INDEPENDENT TECHNICAL REVIEW OF THE HANFORD TANK FARM OPERATIONS

JULY 1992

CONDUCTED BY THE
U.S. DEPARTMENT OF ENERGY
OFFICE OF ENVIRONMENTAL RESTORATION AND
WASTE MANAGEMENT
WASHINGTON, D.C. 20585

Figure F-1. Laboratory Capability and Capacity is the Critical Path in Making "Things Happen."

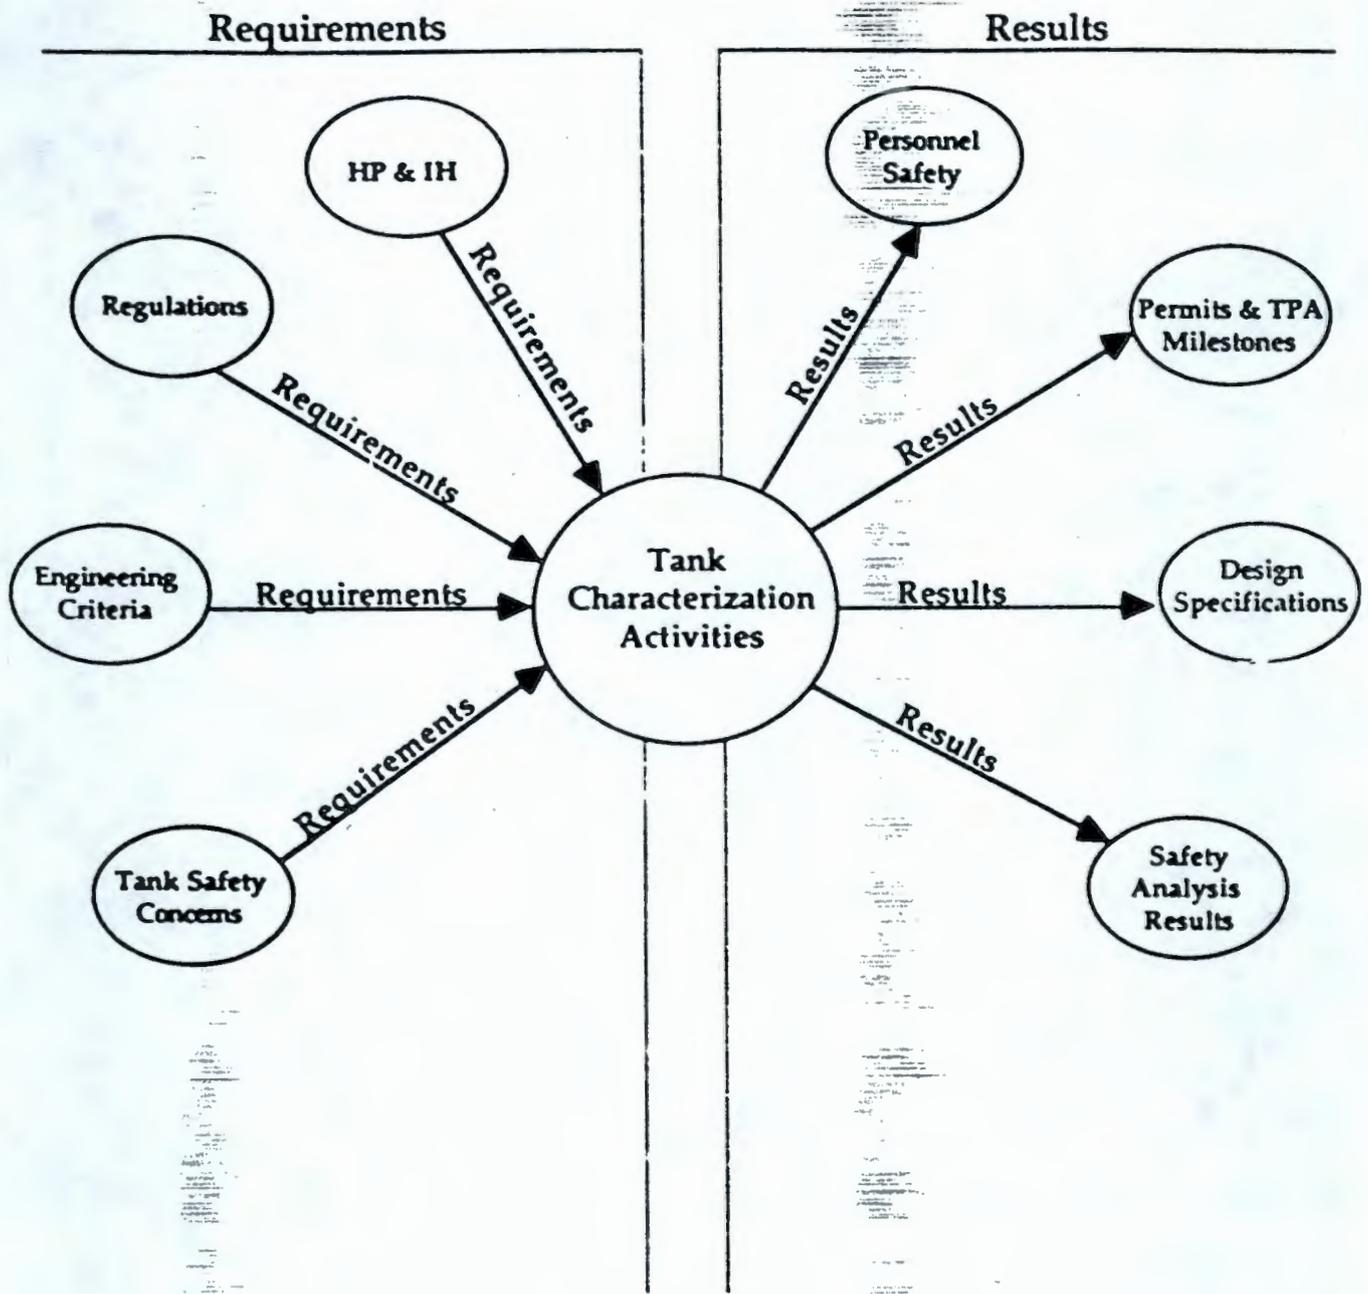
The importance of this waste analysis can be seen by reviewing Figure F-1, which illustrates the multiple requirements for the analysis and indicates the items that are dependent on the results. The recent integration of the sampling needs is a step in the right direction because it attempts to quantify the demands on the laboratory facilities. However, the emphasis remains on meeting the demands of the current project schedules and does not account for new needs that might be identified, nor does it allow for accelerating the analysis to enable the obtaining of needed information earlier than called for on the basis of current planning. (It should be noted that the analytical schedules developed for projects were based not on when the information would be needed, but on when it could be obtained.)
